Syracuse City Planning Commission Meeting February 1, 2022

SHORELINE EAST SUBDIVISION PHASE 3A

**SHORELINE EAST SUBDIVISION
PHASE 3A
2975 SOUTH 3000 WEST
SYRACUSE, UTAH**

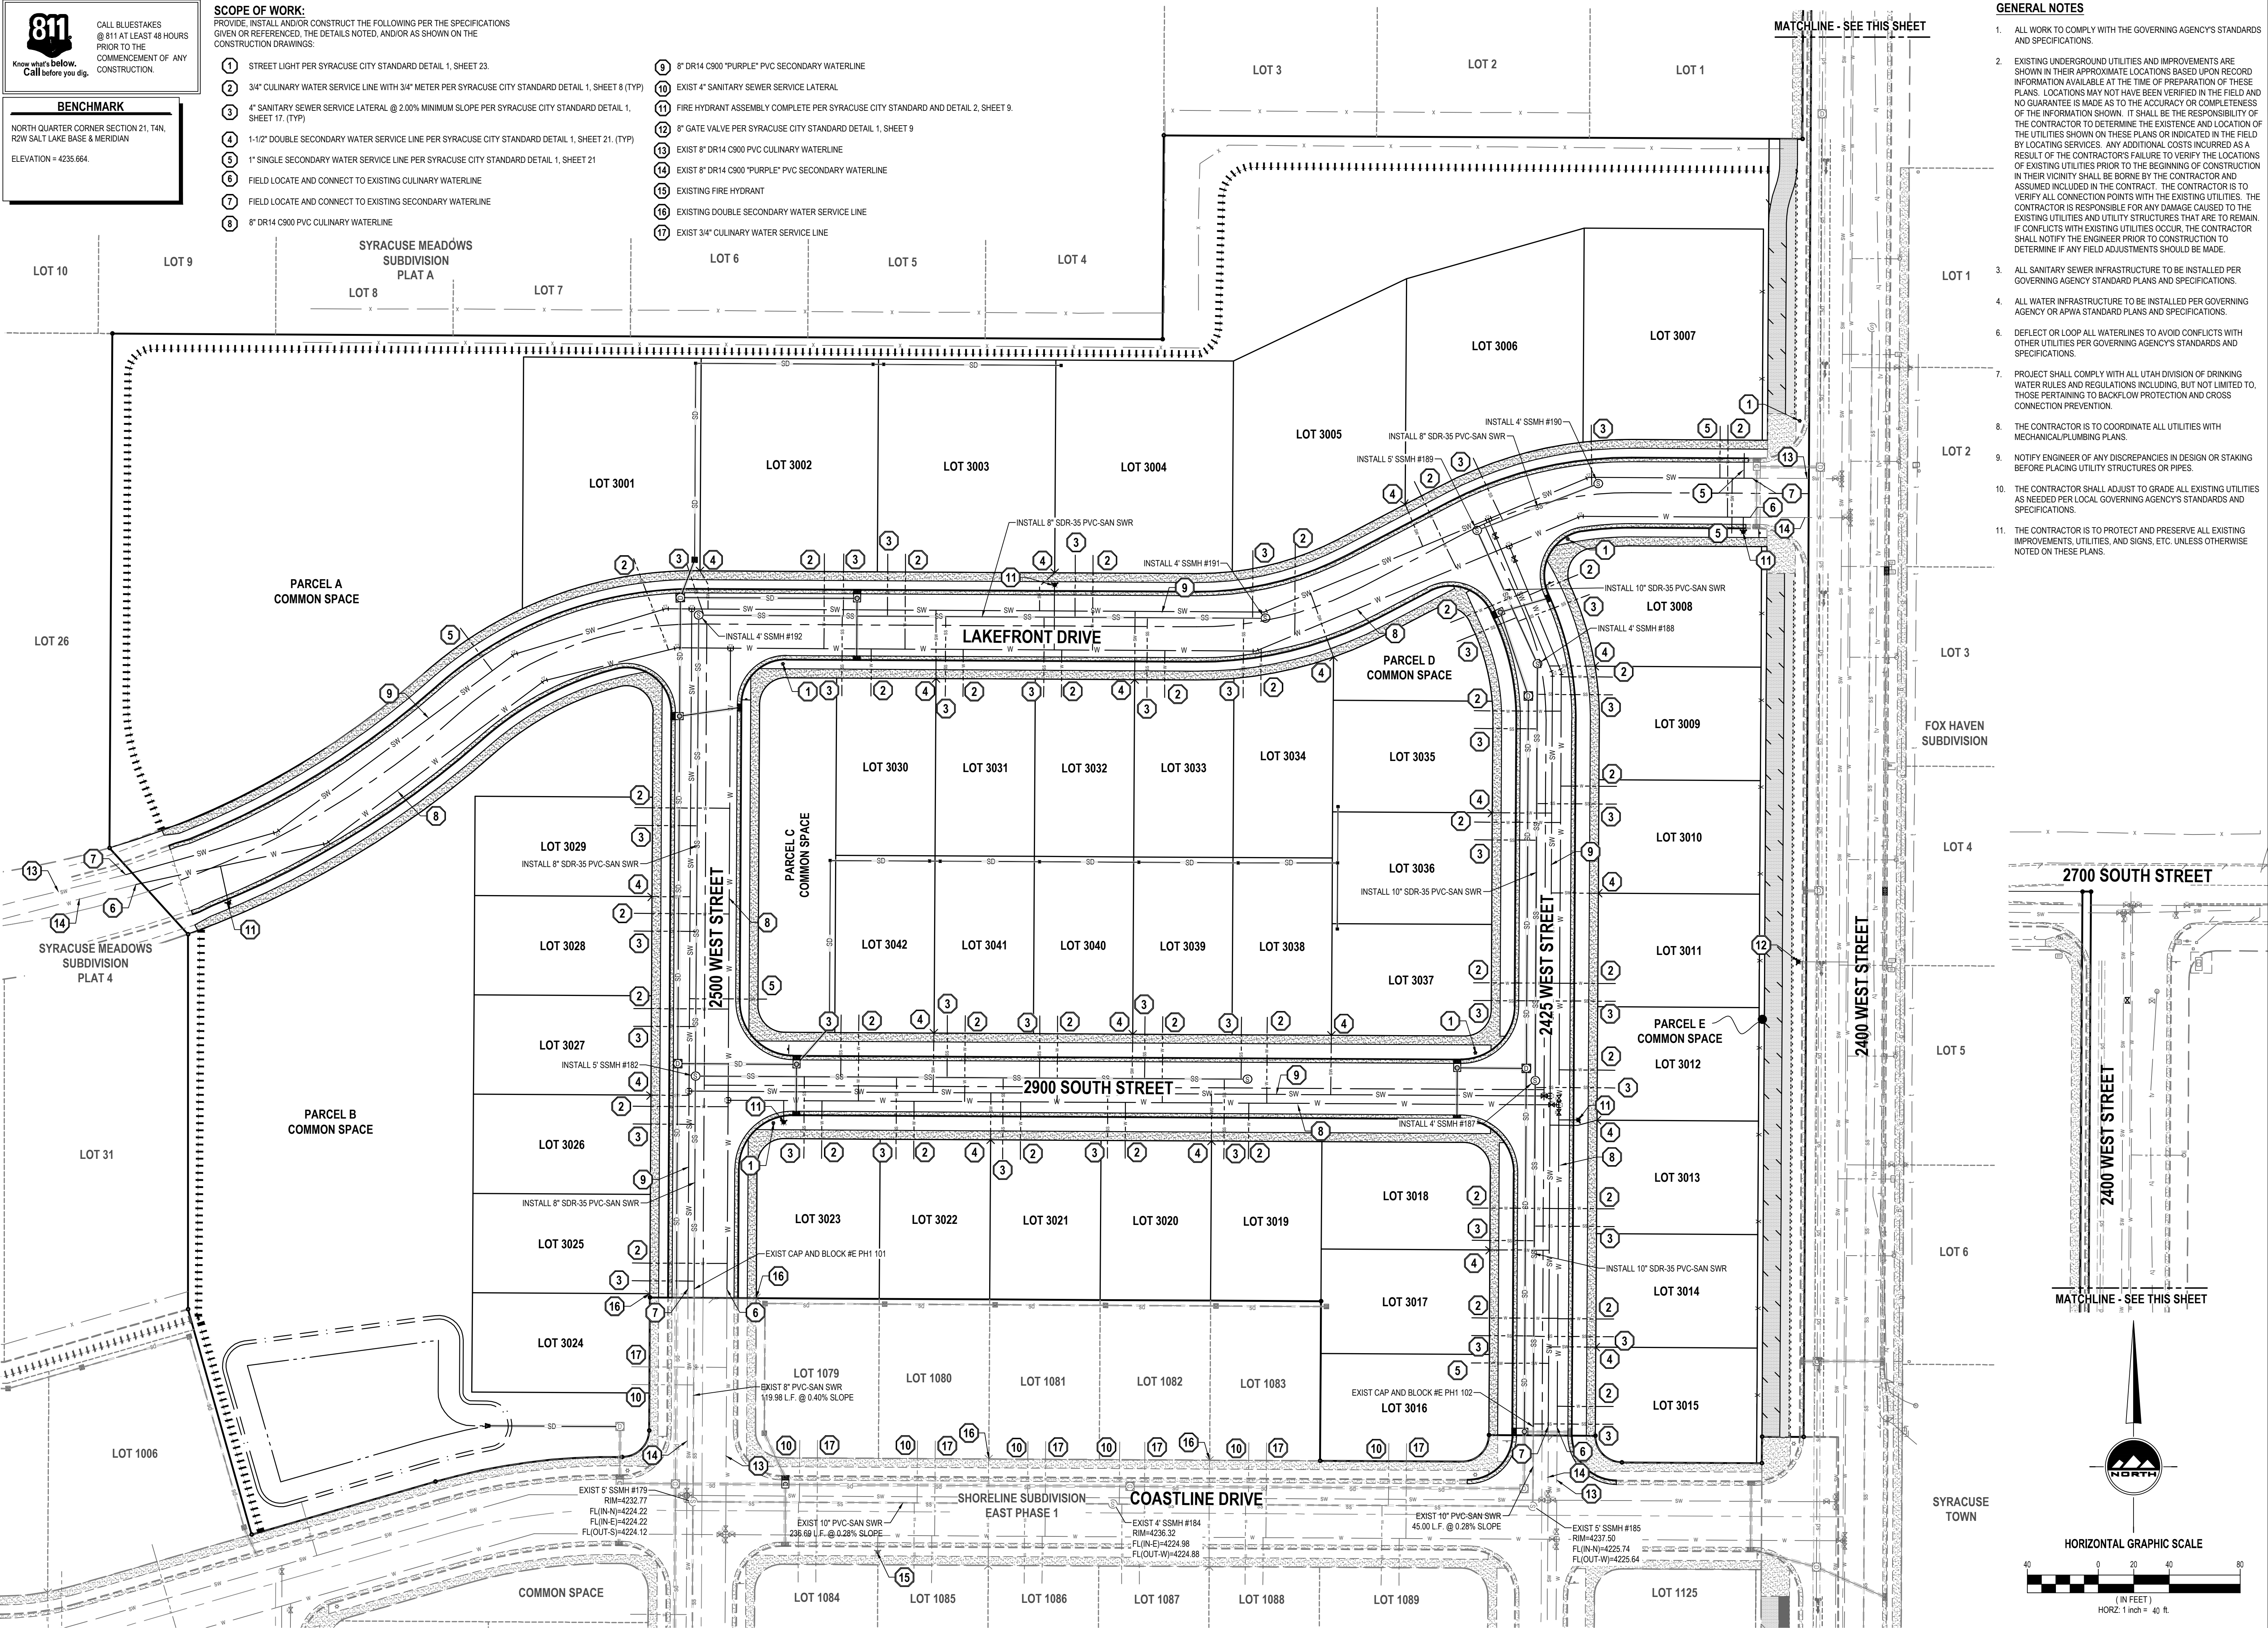
7. Space out the next hydrant properly on Lakefront Drive, ensuring the fire hydrants are no further apart than 500' place on a lot line.
8. Please ensure proper labeling on the index on sheet C300. The fire hydrants were labeled incorrectly
